**PLANNED UNIT DEVELOPMENT  
& SUBDIVISION STAFF REPORT****Date: August 5, 2010**

| <b><u>DEVELOPMENT NAME</u></b>      | Outlaw 2 Lot Subdivision   |
| <b><u>CONTEMPLATED USE</u></b>      | Planned Unit Development Approval to allow two buildings on a single building site and shared access and parking, and Subdivision approval to create 2 lots. |

# SITE PLAN

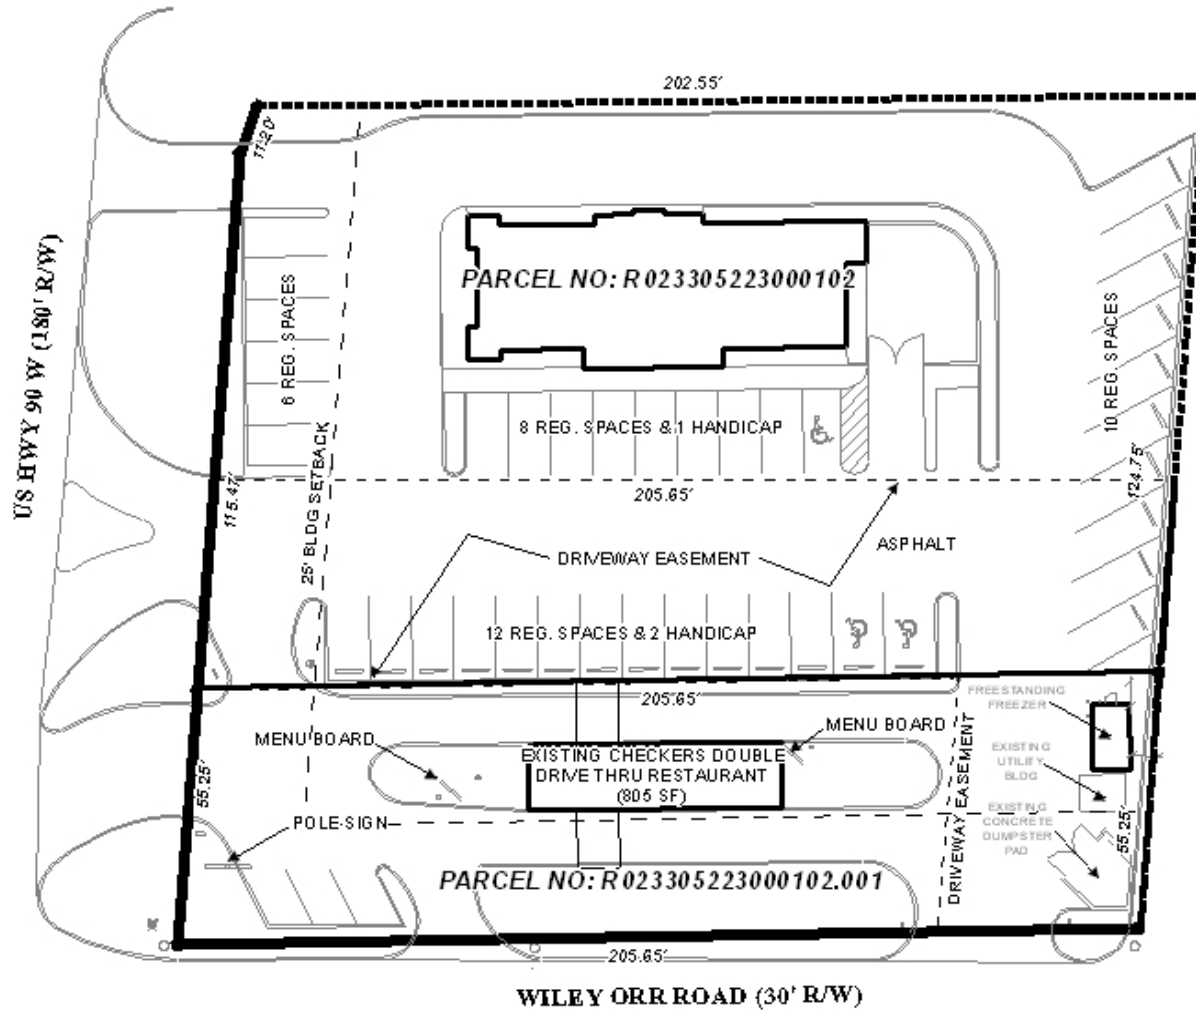
Regarding site circulation, there appears to be sufficient aisle widths and compliant access maneuvering areas. In regards to parking, the site is required to have a total of 38 parking spaces due to the two restaurants and the site plan illustrates 42 parking spaces.

The 25-foot minimum building setback line is depicted on the preliminary plat, and should be retained on the Final Plat along all rights-of-way, if approved. The setback line should be revised to reflect any required dedications.

- 1) obtain a right-of-way use agreement for the parking and signage, if necessary, due to dedication;
- 2) revision of the site plan to reflect right-of-way dedication along U.S. Highway 90 West and Wiley Orr Road;

- 3) revision of the site plan to illustrate the square footage of the Popeyes restaurant;
- 4) revision of the site plan to illustrate the number of employees that can work at Checkers at any give time and depiction of the outdoor seating area;

- 5) placement of a note on the site plan stating that the site is limited to the existing curb-cuts along U.S. Highway 90 West and Wiley Orr Road with the size, location, and design of any additional curb-cuts to be approved by Traffic Engineering and ALDOT and conform to AASHTO standards;

- 6) retention of the 25-foot minimum building setback line along U.S. Highway 90 West and Wiley Orr Road adjusted for any required dedications;
- 7) retention of the labeling of the size of the lot, in square feet, or provision of a table on the plat with the same information;

- 11) placement of a note on the site plan stating that any changes to the site plan will require new applications for Planned Unit Development Approval prior to the issuance of any permits;
